Kilmore Wallan Bypass EES Inquiry and Advisory Committee Report

17 November 2014

Draft Amendment C97 to the Mitchell Planning Scheme

Figure 6-5: EES traffic modelling Sydney Street

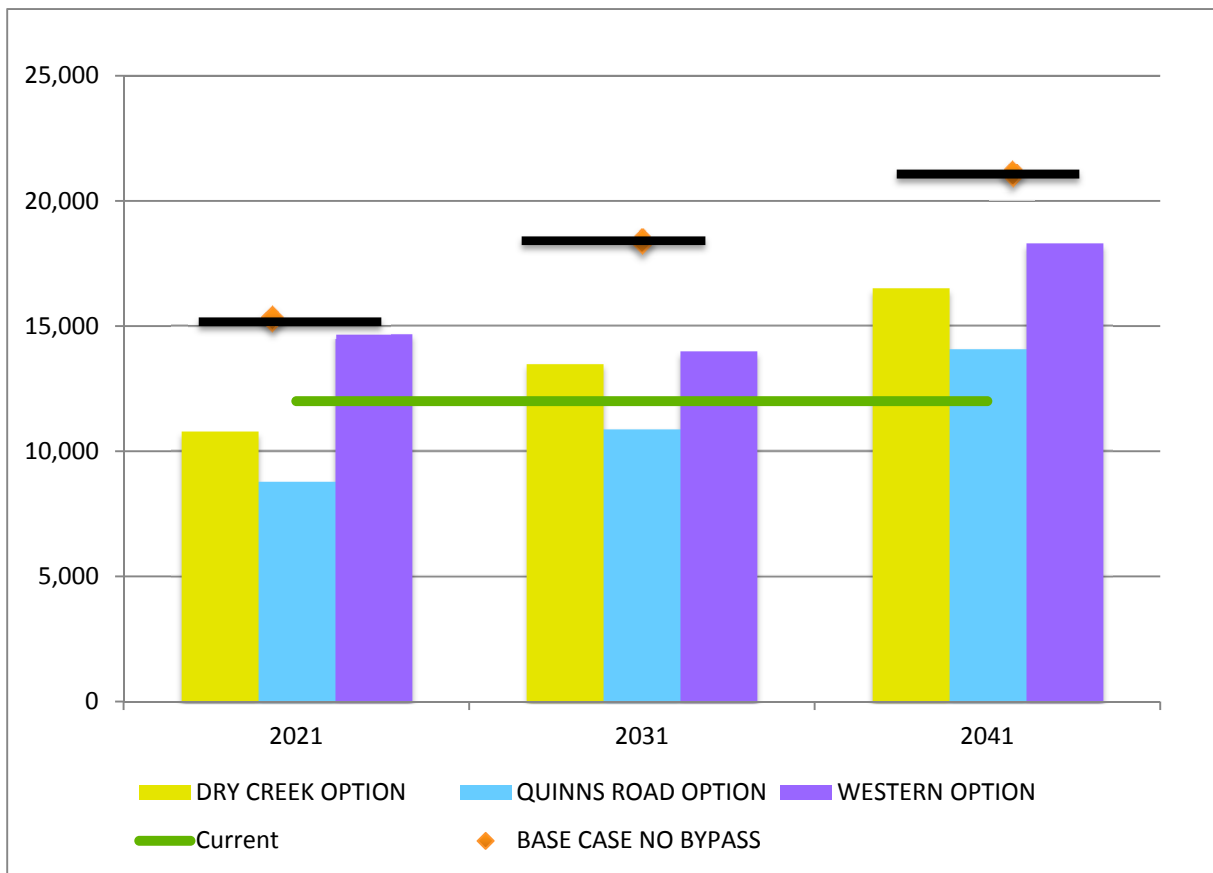
Putting aside the Inquiry's concerns over the modelling, it is worth reflecting on whether the reductions the model predict are sustainable. The model shows they are not. Figure 6-5 shows how by 2031 the traffic in Sydney Street is better than a business as usual scenario, but it is about the same as current levels for all options. The project rationale includes to improve the amenity and attractiveness of commercial precincts in and around the Northern Highway –this implies improving them over the long term, not just for 15 years or so.

The Inquiry thinks that the long term transport connectivity issues should be the primary determinant of assessing whether transport objectives are met, rather than the short term improvements identified in the traffic modelling. The Inquiry’s ratings are shown in Figure 6-6.

Figure 6-7 Alignment in vicinity of Kilmore Wastewater Management Facility

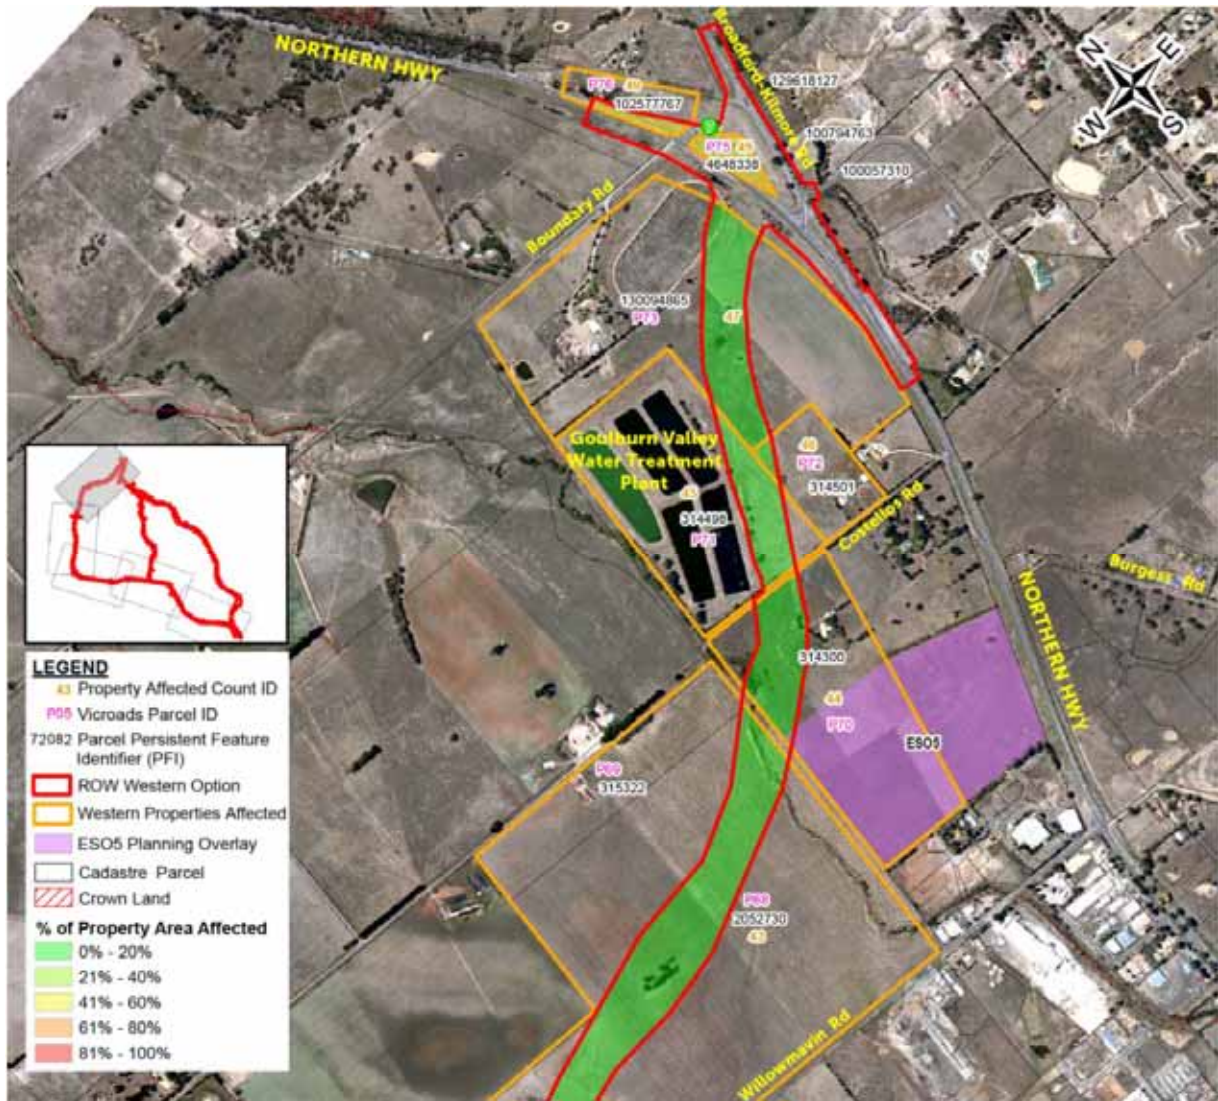
The detailed design of the bypass in the vicinity of the Kilmore Wastewater Management Facility could be refined to reduce potential impacts on the facility. The Inquiry believes that a technical solution may be possible to allow the facility to remain on its current site, but if this is not the case, the costs of compensation for relocation will need to be added into the project costs.

The Western option passes through a portion of land subject to the Environmental Significance Overlay (ESO5) to the Mitchell Planning Scheme to the south of the Kilmore Wastewater Management Facility (WMF). The WMF is operated by the Goulburn Valley Regional Water Corporation (GVW). Figure 6-7 shows the proposed alignment in the vicinity of Kilmore Wastewater Management Facility

- 2. VicRoads and Goulburn Valley Water work together to refine the detailed design of the bypass in the vicinity of the Kilmore Wastewater Management Facility generally along the alignment proposed in the Environmental Effects Statement. The design work should explore reconfiguration or relocation of the plant with the view of achieving an efficient ‘whole of government’ resolution of the infrastructure needs of Kilmore.**
